Re: **License SUA-1473 Docket 40-8905**
Response to October 31, 2005 Request for Additional Information

Response to Request for Additional Information

**Rio Algom Mining LLC
License Amendment For Alternate Concentration Limits
Non-hazardous Constituents**

**Prepared by
Maxim Technologies, Inc.**

Figure 1
Long Term Site
Maintenance
Boundary

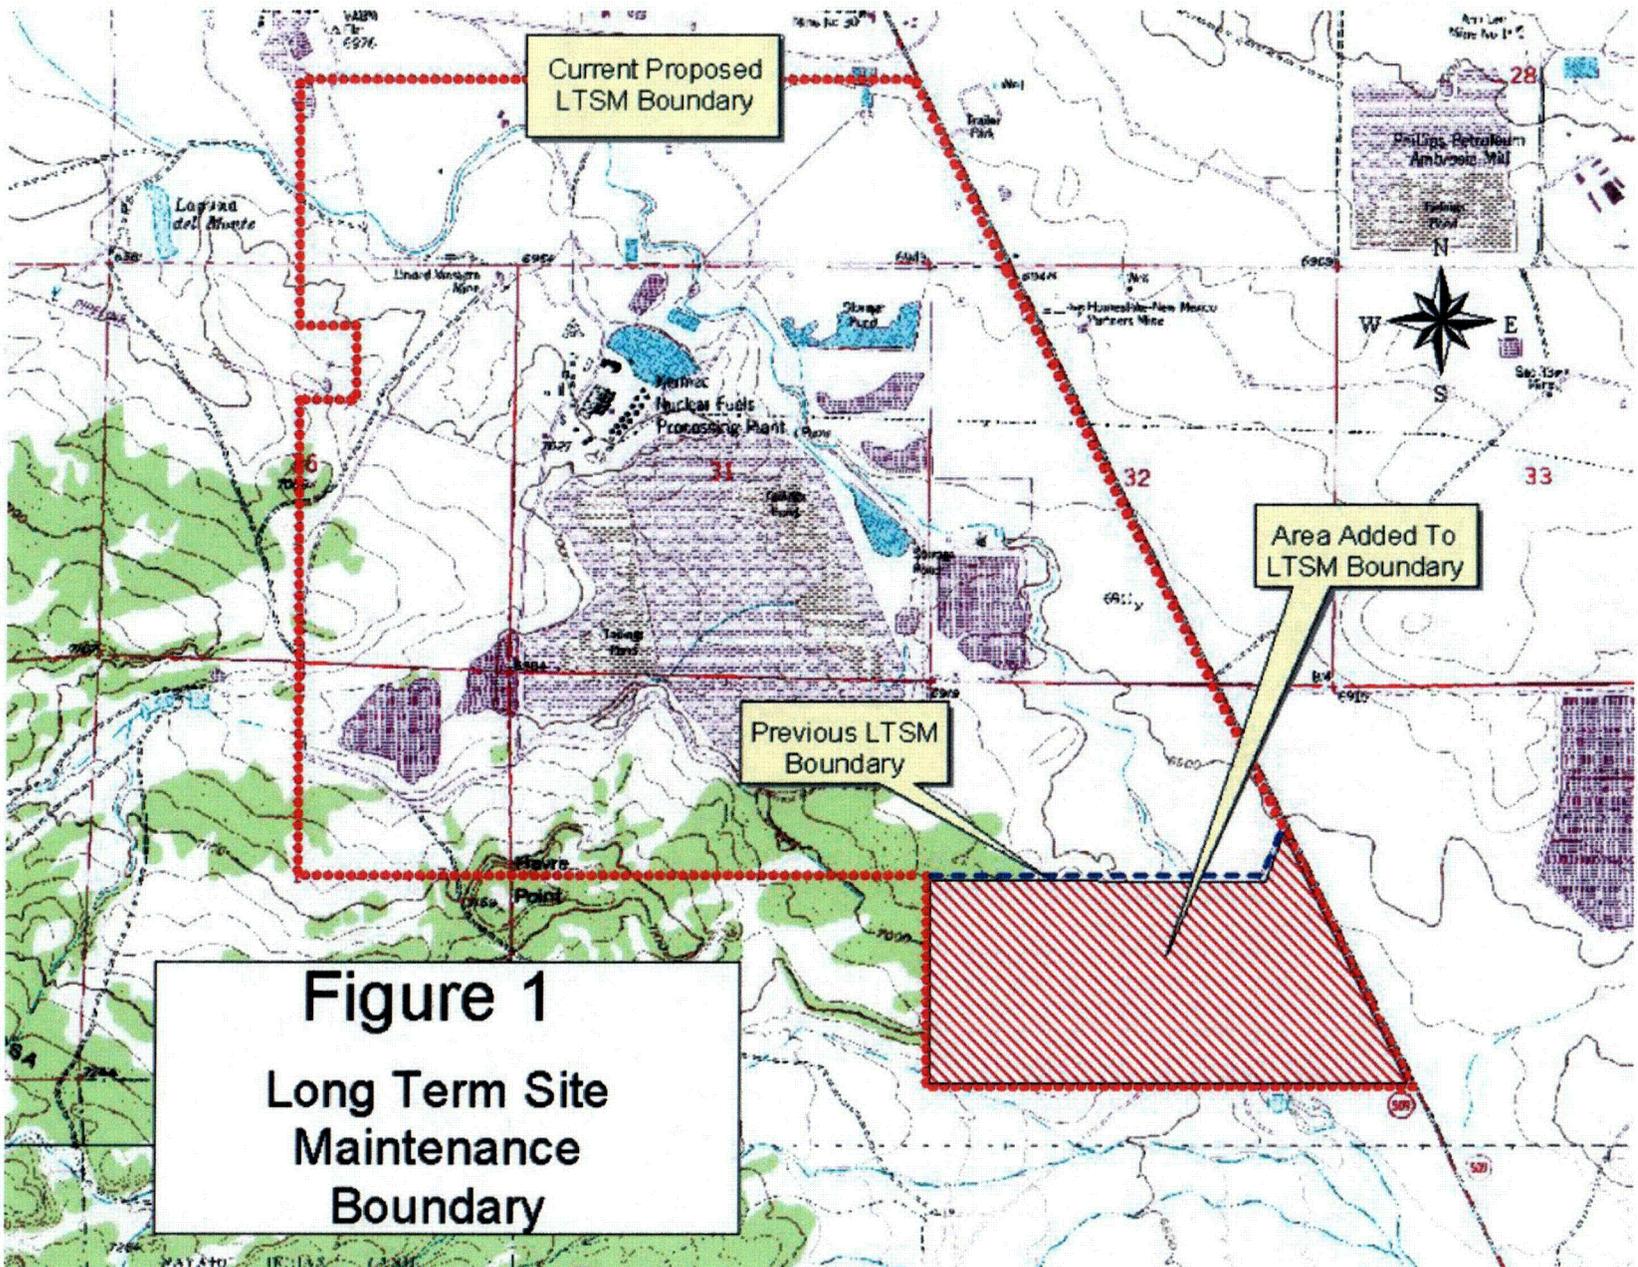
RAM should provide an assessment of the non-hazardous constituent concentrations in ground water at the point of exposure (POE) and the methods used in this assessment.

Rio Algom has requested that the DOE Office of Legacy Management establish the Long Term Surveillance and Maintenance (LTSM) boundary to include the southern part of Section 5 and that portion of Section 4 that is west of Highway 509 (Figure 1). This boundary is necessary in order to support the ACL application. Monitor well MW-24, which is located in the southwest corner of Section 4 approximately 2800 feet southeast of well 5-08, will constitute the POE for the alluvium. However, in order to maintain consistency with past model work, the following analysis was performed by maintaining the POE at well 5-08.

Figure 6.
CALCULATED WATER-LEVEL DECLINE BY OCTOBER 1979
(PHILLIPS SJ-109 ORDER DATE)

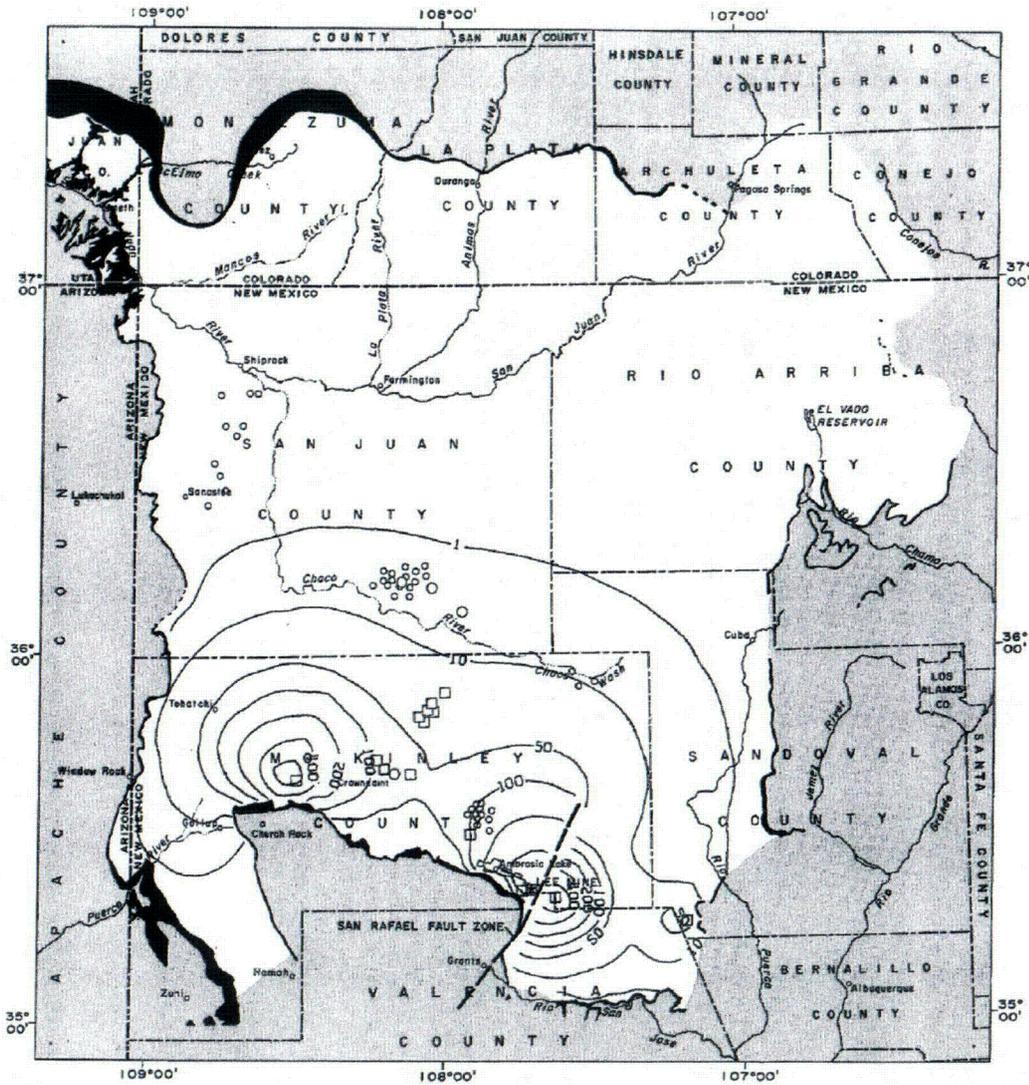
RAM mentions that extensive mining in the Ambrosia Lake area caused the dewatering of the Westwater Canyon Member of the Morrison Formation, which is the mined unit in this area. Extensive dewatering has formed a cone of depression that is expected to affect ground water for approximately 600 years. Please confirm the location of this cone of depression.

Figure 6, taken from a 1983 study by William F. Guyton Associate, Inc, is an estimate of the drawdown and extent of the groundwater depression due to mine pumping by 1979. This figure (similar to several others that have been published – c.f. Stone, 1983) indicates that the area affected by drawdown due to mine pumping at Ambrosia Lake may be as much as one thousand square miles of the San Juan Basin. Note that the highest head loss is centered on the Ambrosia Lake site.

Figure 7. Chloride in the Dakota Solute Model

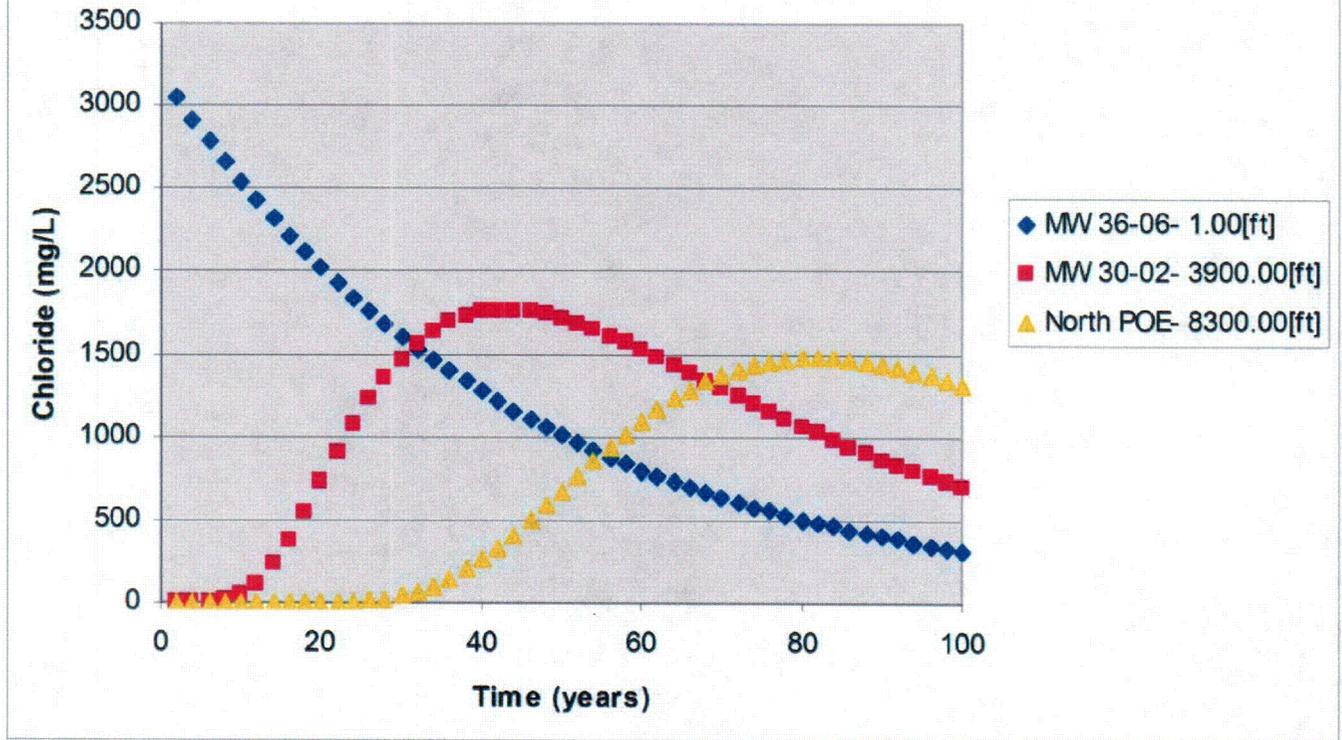
RAM states that the non-hazardous ACLs will be the same for both the alluvial and bedrock aquifers. This does not appear to be technically defensible. Although ground water would migrate from the alluvial to the bedrock aquifers, attenuation to some degree would likely occur. This is evident by the proposed ACLs for the hazardous constituents, which are lower for the bedrock aquifers than for the alluvial aquifer. RAM should present its rationale for proposing similar bedrock and alluvial ACLs.

Rio Algom used modeling procedures identical to those described above (Comment 2) to assess concentrations of non-hazardous constituents at the POE over time. Results are presented in Figure 7 (chloride), Figure 8 (nitrate), Figure 9 (sulfate), and Figure 10 (TDS). Modeling was only completed for the Dakota because the transport distance is the same as that for the other units and initial concentrations of all constituents were highest in the Dakota.
